SERVICE NO. 540B BULLETIN

Date: February 9, 2021

**INSPECTION AND REINFORCEMENT OF
STABILATOR TIP TUBE AND WEIGHT ASSEMBLY**

PA-23-250 (Six-Place) Aztec "F"

Figure 2
 Side View of Tube and Weight Assembly

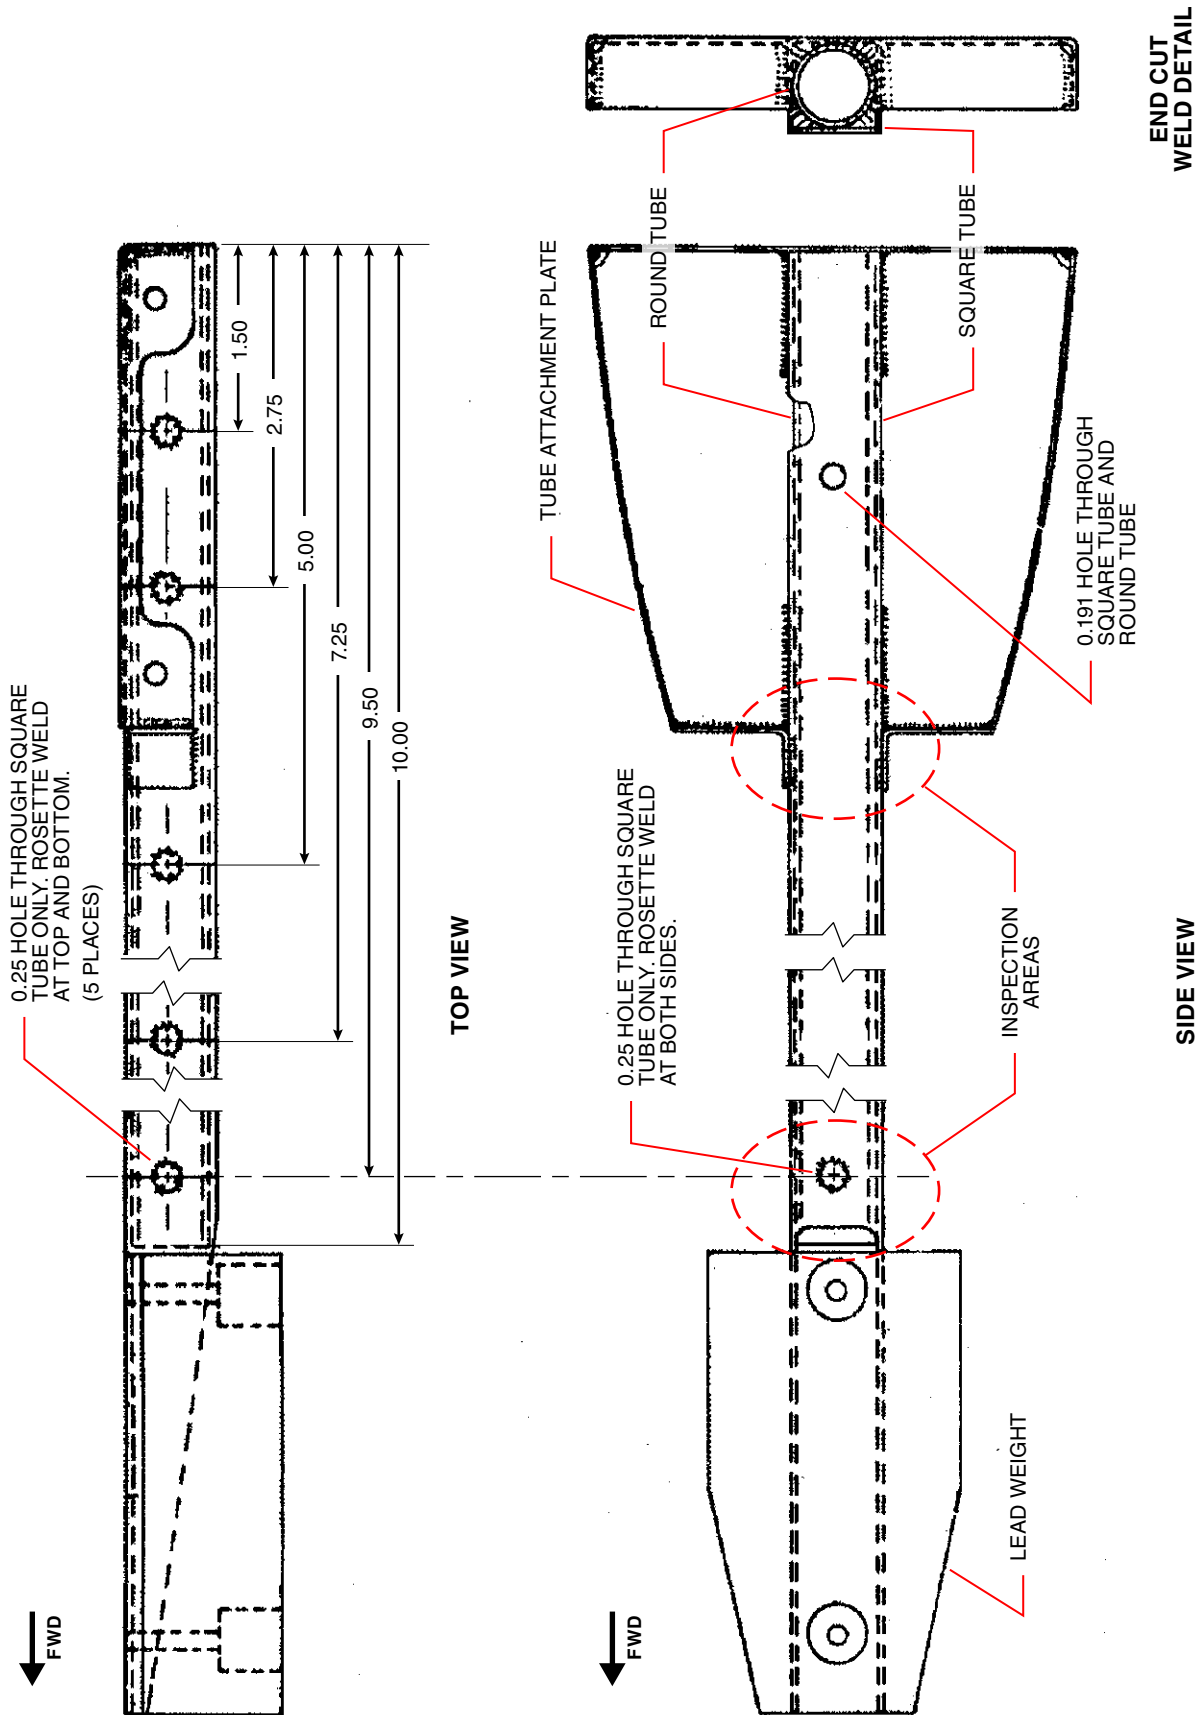
4. RC – For S/Ns 27-7954036 through 27-7954121; and for S/Ns 27-7654001 through 27-7954035 if Stabilator Balance Weight Replacement Kit, P/N 763-987, is installed: examine the inspection areas identified in Figure 2. Perform the inspection using a 10X magnifier, a mirror, and a suitable light source or other equipment capable of providing equal or better resolution.
 - **If cracks are found**, then repair is necessary prior to next flight. Contact Piper Customer Service for assistance at (+1) 772-299-2141 or CustomerService@piper.com. Piper’s normal business hours are Monday through Friday, 7:30 a.m. to 4:30 p.m. (Eastern).
 - **If no cracks are found**, then proceed to Part III.

SIDE VIEW
 APPLICABLE TO S/N 27-7654001 THROUGH 27-7954035 WITH PIPER KIT
 P/N 763-987 INSTALLED, AND S/N 27-7954036 THROUGH 27-7954121

Figure 1
Top View and Side View of Tube and Weight Assembly

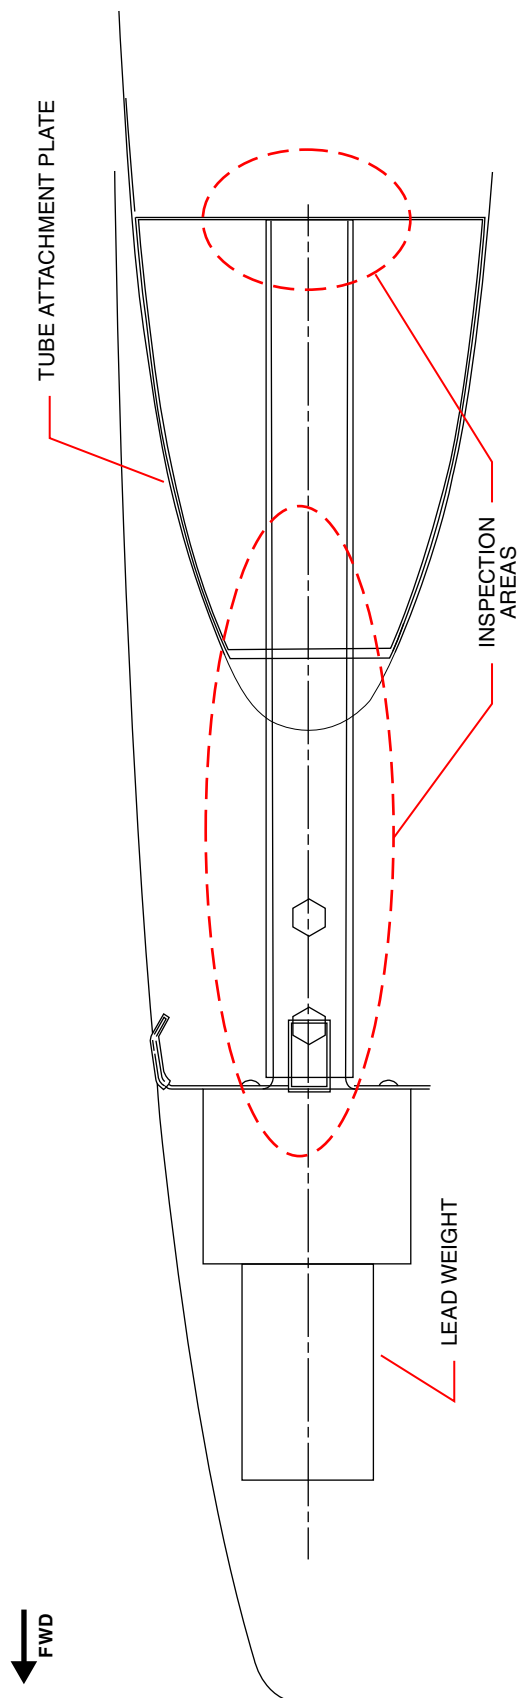
3. RC – For serial numbers (S/Ns) 27-7654001 through 27-7954035 if Stabilator Balance Weight Replacement Kit, Piper P/N 763-987, **is not installed**: examine the inspection areas identified in Figure 1. Perform the inspection using a 10X magnifier, a mirror, and a suitable light source or other equipment capable of providing equal or better resolution.

- **If cracks are found**, repair the tube and weight assembly as described in Part II, prior to next flight.
 - **If no cracks are found**, then proceed to Part III.

NOTE: Figure 1 shows a stabilator tip tube and weight assembly after repair.

RC – These repair instructions are applicable only to S/Ns 27-7654001 through 27-7954035 without Kit P/N 763-987 installed. Refer to Figure 1.

- b. Cut or drill a hole in the end of the tube attachment plate to allow a 5/8 inch diameter tube to be inserted into the square tube.
 - c. Locate and drill twelve (12) 0.250 holes in the square tube as shown in Figure 1.

- d. Insert a 10-inch length of round steel tube (5/8 x 0.058 Type 4130 Cond. N) into the square tube and rosette weld the tubes together at the twelve (12) 0.250 holes.

- e. Weld shut the area around the hole in the attachment plate and the tubes.
 - f. Weld shut any cracks that were discovered when inspecting the square tube.

- g. Drill a 0.191 hole through the round tube using existing hole in square tube as a guide.
- h. Clean, prime and paint tube and weight assembly.
- i. Reinstall the tube and weight assembly to the stabilator using existing attachment hardware.
